Comments on the Preliminary Staff Assessment

Application for Certification (06-AFC-9) for COLUSA GENERATING STATION Colusa County, California

**Comments on the Preliminary Staff Assessment
Colusa Generating Station
August 17, 2007**

Proposed Modifications to Glenn-Colusa Canal Bridge Design for COLUSA GENERATING STATION Colusa County, California

**REVISED GLENN-COLUSA CANAL
BRIDGE DESIGN AND STAGING AREA**

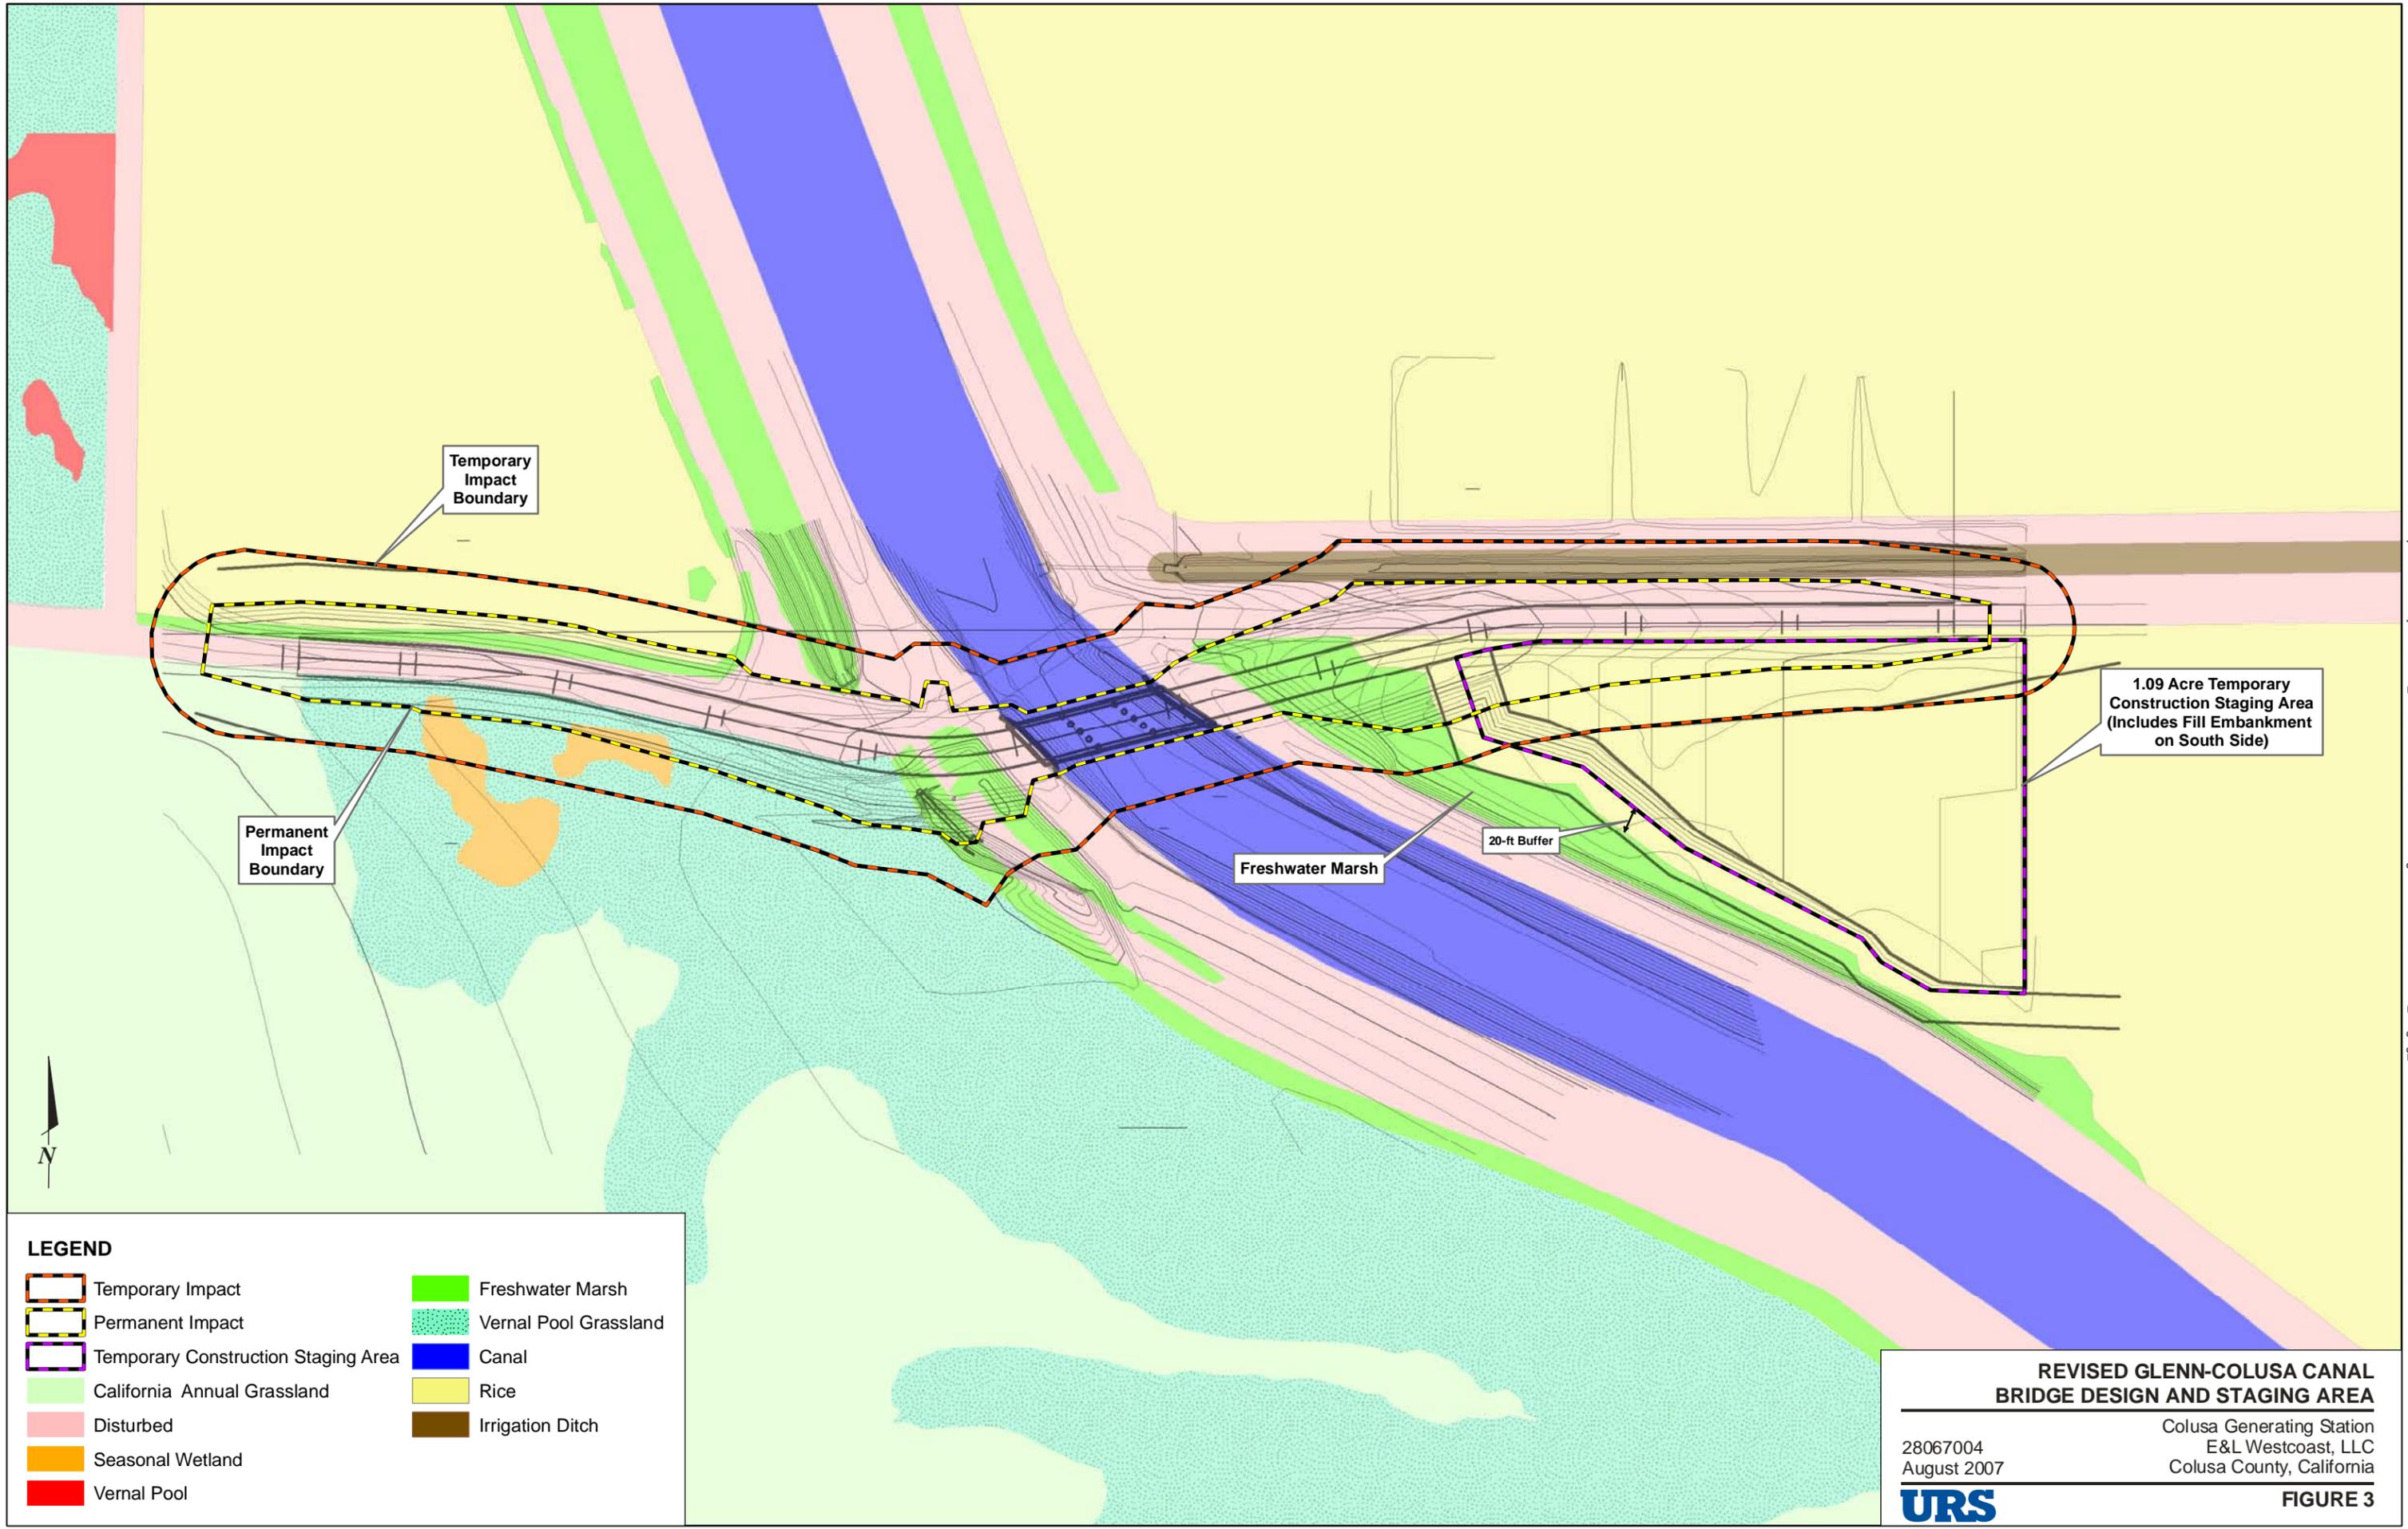
4.	Section 3, Project Description	Page 3-3, Existing Bridge and Road Modifications, 2 nd paragraph	Referring to the Glenn-Colusa Canal Bridge improvement: “The new bridge will be a free-span steel beam and concrete structure approximately 100 feet long by 30 feet wide. This bridge design would provide two 12-foot lanes with 3-foot shoulders giving unimpeded two-way traffic flow. No	The design of the new Glenn-Colusa Canal Bridge as proposed in the AFC has been modified to address recommendations by adjacent property owners. The revised bridge design would relocate the new Glenn-Colusa Canal Bridge to the south of the existing bridge rather than north of the existing bridge. Attachment A provides additional details and figures regarding the bridge design modification. Below is a summary of the revised bridge design.

Comment Number	PSA Section	Page Number	PSA Statement	Comments to CEC
			piers will be constructed in the canal to support the bridge. The east approach will be located approximately 20-feet to the north of the existing bridge and the west approach will located approximately 40-feet north of the bridge.”	<p>The new bridge will be a three-span steel beam and concrete bridge approximately 100 feet long by 30 feet wide. This would provide for two 12-foot lanes with 3-foot shoulders giving unimpeded two-way traffic flow, rated for the heaviest equipment for the plant, and will exceed HS-20 rating per AASHTO standards. Two sets of five piers will be constructed in the canal to support the bridge; designed and oriented to reduce impeding the flow of water and to minimize the collection of floating debris. The east approach will be located approximately 75 feet south of the existing bridge and the west approach will be located about 45 feet south. The bridge will be fitted with side guard rails and will be striped to permit safe passage of traffic.</p> <p>The existing bridge is now planned to be removed. The concrete deck will be removed along with the three sets of five piers that are in the canal (water). Removal of the original bridge piers will more than offset the new piers impact on the flow of water in the canal. The two bridge abutments are planned to be left in place to minimize impacts to the canal and the embankments. Leaving the abutments in place will not impact the operation of the canal. The original bridge approaches would be final-graded to match the surrounding land contours and seeded with grass native to the region.</p>

The current proposal is to construct a replacement bridge to the south of the existing bridge rather than to the north (Figure 3). The east approach will be located approximately 75 feet south of the existing bridge, and the west approach will be located about 45 feet south. Similar to the previous bridge design, the access road on both sides will be realigned to straighten and widen the approaches to allow for unimpeded two-way traffic, re-aligning with the current Dirks Road right-of-way as soon as practical. A retainer wall will be placed along the northern side of Dirks Road, on the east side of the replacement bridge, to enable the continued use of the current irrigation canal.

The replacement bridge will be approximately 100 feet long by 30 feet wide and will be a three-span bridge (rather than a free-span design as previously proposed). This would provide for two 12-foot lanes with 3-foot shoulders giving unimpeded two-way traffic flow, rated for the heaviest equipment for the plant, and will exceed HS-20 rating per AASHTO standards. Two rows of five piers will be constructed in the canal to support the bridge; designed and oriented to reduce impeding the flow of water and to minimize the collection of floating debris. Sheet piles will be installed to construct a temporary cofferdam around each row of piers. The inside of the cofferdam will be dewatered and the water will be released back into the canal downstream of the cofferdam. The bridge will be fitted with side guard rails and will be striped to permit safe passage of traffic.

Maximum permanent disturbance is limited to the realignment of the approach roads and backfilling the area (70 by 500 feet) on both sides of the bridge (rather than 40 by 100 feet, as previously proposed). Land disturbance for the current bridge design will involve 1.6 acres of permanent operational impact (rather than 1 acre, as previously proposed).

Under this proposal, the existing bridge will be removed (rather than left in place, as previously proposed). The removal of the existing bridge will occur after the new bridge is constructed to allow continued access over the Glenn-Colusa Canal. The concrete deck and the three sets of five piers associated with the existing bridge will be removed. The piers will be cut off at the mud line and removed during low water conditions, which will allow the work to be done without placing heavy equipment into the canal. Removal of the existing bridge piers will offset potential impacts of the new piers on the flow of water in the canal. The two bridge abutments supporting the existing bridge will be left in place to eliminate construction impacts to the canal embankments. This will not affect the operation of the canal. The original bridge approaches will be final-graded to match the surrounding land contours and seeded with grass native to the region.
